Bike to the Future

Charleswood Transportation Study Submission

3. Create a signalized crossing of Shaftesbury at the bus loop in front of Shaftesbury Park Retirement Residence.

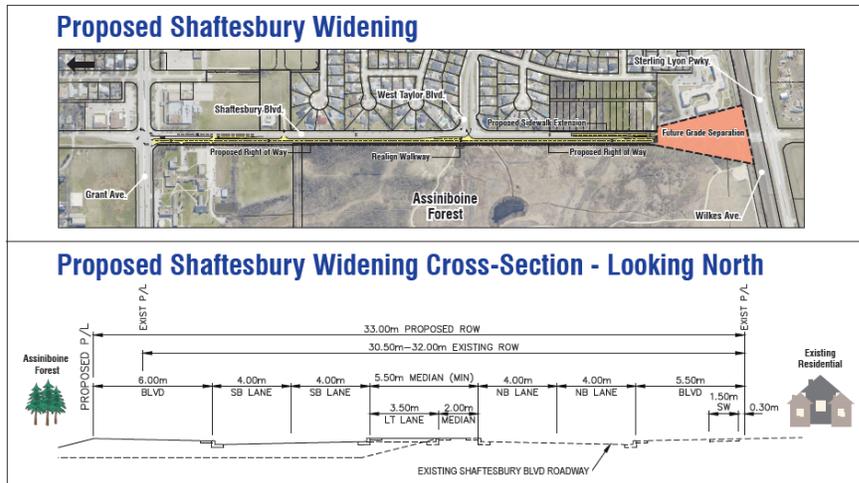
The addition of a signalized crossing at the southern end of the bus loop outside of the Shaftesbury Park Retirement Residence would provide a quality link between the Harte Trail/Assiniboine Forest Trails and the local street network within South Tuxedo. Currently pedestrians and cyclists must cross the rail tracks to before crossing Shaftesbury, causing a significant degree of detour and delay. Paired with a multi-use pathway connecting into Litchfield, a signalized crossing at this location would provide a much needed connection into Park, which is identified in the Kenaston Widening plan as a key North/South cycling route through Tuxedo.

Schematics from Route 90 Study include sidewalks and a separated two way bicycle path – taken from City of Winnipeg web-site

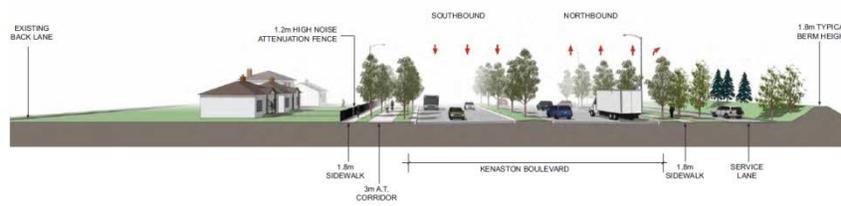
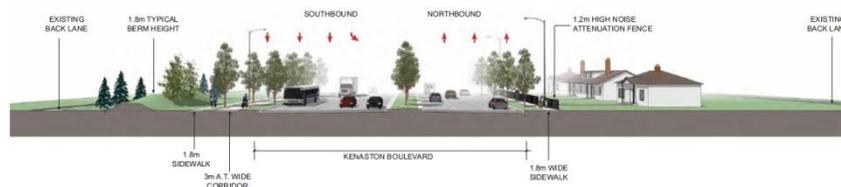
Similarly, while the planned widening of Kenaston is noted as part of the road network, no such reference is included in the AT map, despite the fact that considerable effort was expended on AT planning as part of the Route 90 (Kenaston) Study, and the approved plans include significant AT facilities.

Recommendations related to AT from the Route 90 (Kenaston) study/plan should be incorporated into this study's AT review.
